**PROPOSED DEVELOPMENT: ELIZABETH CRESCENT, WHITEHAVEN
STAGE 1 ROAD SAFETY AUDIT AND DESIGNER'S RESPONSE**

**PROPOSED DEVELOPMENT: VICTORIA ROAD/BAY VISTA, WHITEHAVEN
STAGE 1 ROAD SAFETY AUDIT AND DESIGNER'S RESPONSE**

**Land off Elizabeth Crescent, Whitehaven
Victoria Road/Bay Vista - Proposed Junction Alterations
Stage 1 Road Safety Audit**

Report No. A102063/RSA1

PROPOSED JUNCTION ALTERATIONS
VICTORIA ROAD/BAY VISTA

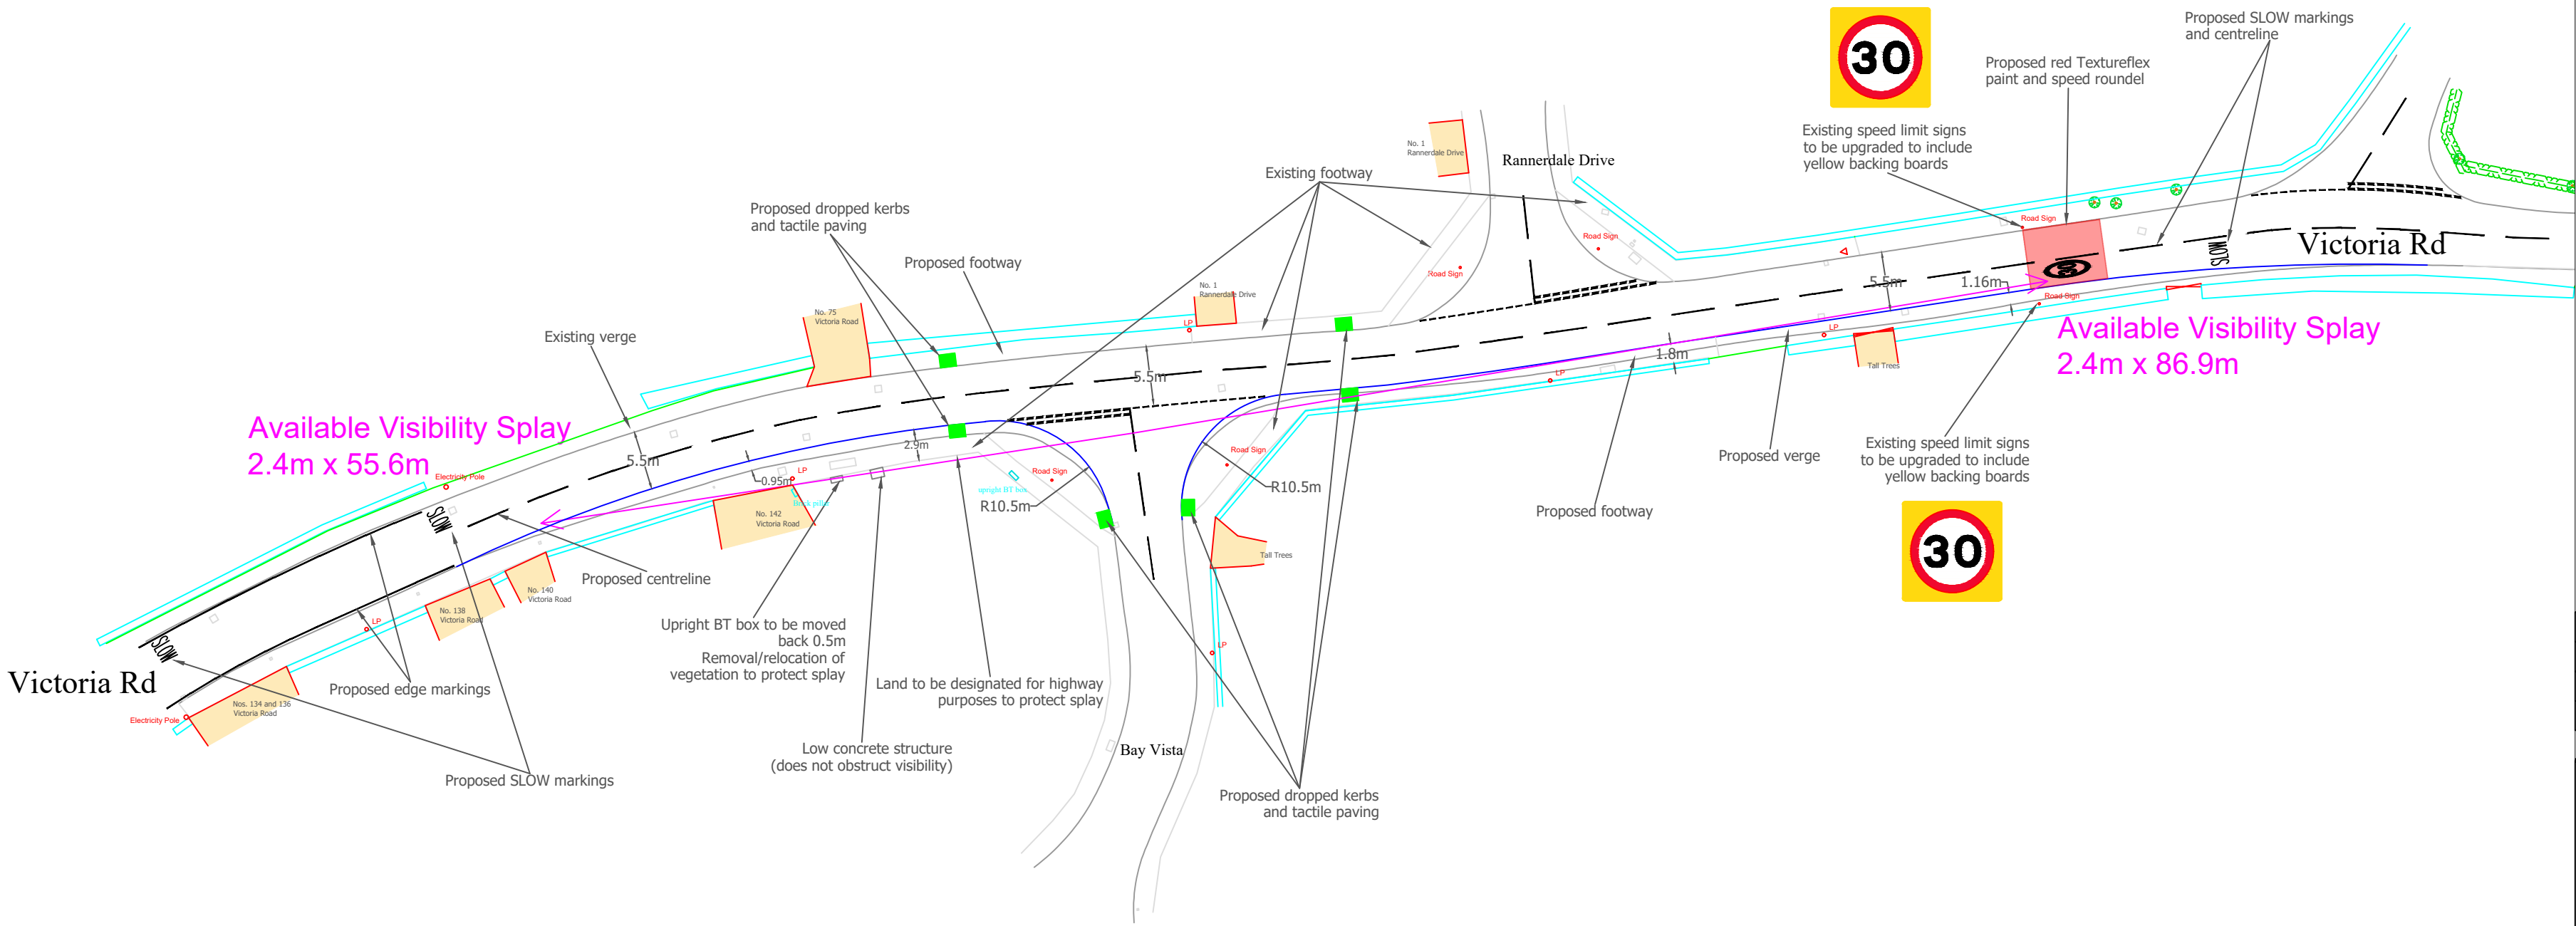
Audit Reference	Problem Summary and Recommendation	Designer's Response
3.1	<u>Location:</u> The junction of Victoria Road with Bay Vista. <u>Summary:</u> The existing roadside features could compromise mutual visibility at the junction. The land to the west of the junction is to be designated for highway purposes in order to protect the visibility splay and the upright BT box that lies partially within the splay is to be set back. However, there are currently overhanging tree branches and shrubbery close to the splay that could compromise visibility (especially when in full growth), but are not specified for treatment. The absence of mutual visibility at the junction could increase the risk of turning collisions involving both vehicles and pedestrians. <u>Recommendation:</u> It is recommended that the detailed design drawings specify the removal or relocation of trees and shrubbery that could compromise visibility, taking into account the potential for re-growth.	<u>Response:</u> Recommendation is accepted and has been included on the updated drawing, C001D.

3.2	<u>Location:</u> The pedestrian crossing point on Bay Vista. <u>Summary:</u> The location of the crossing could increase the risk of vehicles colliding with pedestrians. The dropped crossing point on the east side of the road is located to coincide with the end of the angled footway, but is within the existing driveway serving Tall Trees. The location of the crossing could increase the risk of collisions between waiting pedestrians and vehicles entering or leaving the driveway. In addition, motorists beginning the turn into the driveway might brake suddenly to allow pedestrians to clear the driveway, with the attendant risk of tail end strikes from following vehicles. <u>Recommendation:</u> It is recommended that the crossing is located outside the extents of the driveway. If it is installed to the north, short sections of footway	<u>Response:</u> Recommendation is accepted and has been included on the updated drawing, C001D.

may need to be constructed to connect the existing angled footways to the crossing points.	
3.3	<u>Location:</u> The junction of Victoria Road with Bay Vista. <u>Summary:</u> The incorrect pattern of tactile paving could increase the risk of vehicles colliding with pedestrians. Although only schematic at present, the drawing shows shapes for the tactile paving at the pedestrian crossing points that could be construed as two or three rows. If specified and installed as such, they could be interpreted by visually impaired pedestrians as crossings remote from a junction rather than inset from it. This could make them unaware of the possibility of encountering turning vehicles and increase the risk of collisions. <u>Recommendation:</u> It is recommended that the tactile paving at each crossing point is specified as a depth of 400-450 mm (a single row of paving) – the pattern for that of an inset crossing – as the detailed design progresses. However, if the recommendation in 3.2 above is accepted and progressed, and the crossing is located to the south of the driveway serving Tall Trees, the pattern for that crossing should be specified as that remote from a junction.	<u>Response:</u> Recommendation is accepted. The pattern of tactile paving will be specified to the appropriate crossing types during the detailed design stage.

3.4	<u>Location:</u> Victoria Road. <u>Summary:</u> Differential grip could lead to pedestrians slipping and falling. The scheme involves a new section of footway and a footway widening. If a different type of surface finish is used for the new areas of footway compared with the existing, it is possible that, in wet or freezing conditions, the two finishes could look similar but exhibit different degrees of slip resistance, increasing the risk of slips and falls as users move from one surface to another. <u>Recommendation:</u> It is recommended that the existing and new surface materials have similar properties in terms of slip resistance in wet or freezing conditions.	<u>Response:</u> Recommendation is accepted and surface materials will be specified at the detailed design stage.

D	ALTERATIONS FOLLOWING RSA1			EB	NB	NB	06.01.20
C	ALTERATIONS TO ROAD MARKINGS & TACTILE PAVING			CGQ	NB	NB	03.12.19
B	ADDITIONAL WESTERN GATEWAY FEATURES ADDED			EB	NB	NB	13.09.19
A	TAPER EXTENDED EAST. PAINT & DROP KERBS ADDED			EB	NB	NB	15.08.19
REV	DESCRIPTION			BY	CHK	APP	DATE
